SERVICE BULLETIN

M-885

April 10, 1984

INFORMATION UPDATE — ALL MODELS

Figure 1. Front Brake Caliper Mounting

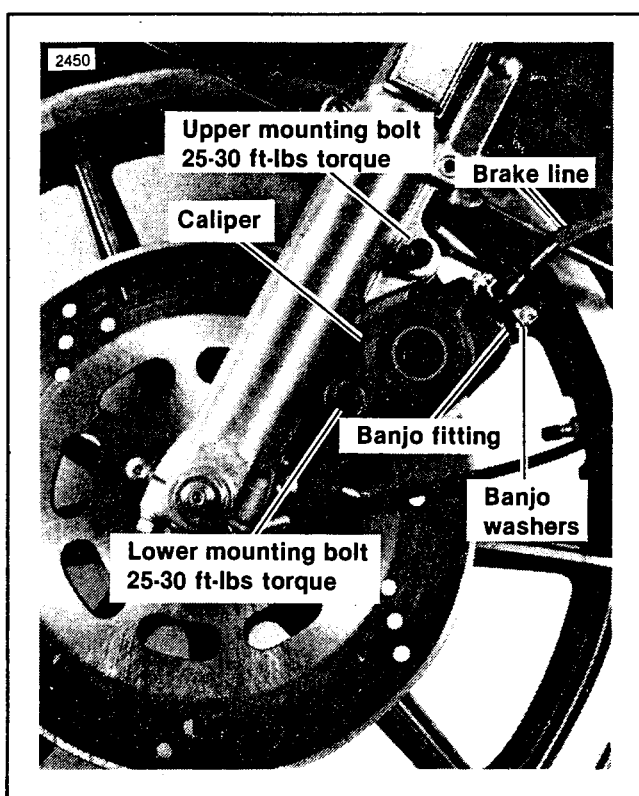
Front Caliper Mounting Bolt Torque

The torque specification for the front caliper mounting bolts has been reduced from 40-45 ft-lbs to 25-30 ft-lbs. See Figure 1.

Figure 2. 1340cc Crankcase Set

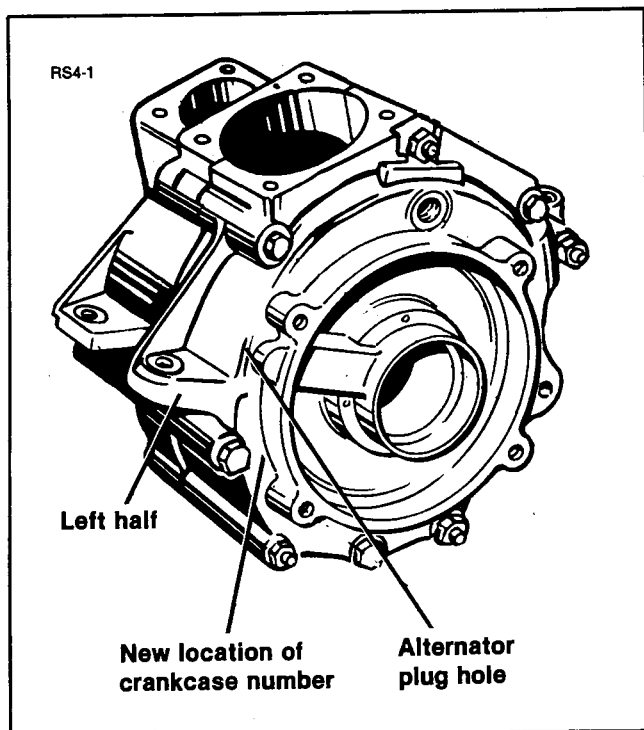
Changed Crankcase Number Location

To aid the stamping operation, the locations of the crankcase numbers were changed as specified in Table I. See Figures 2 and 3 for illustrations of the new locations.
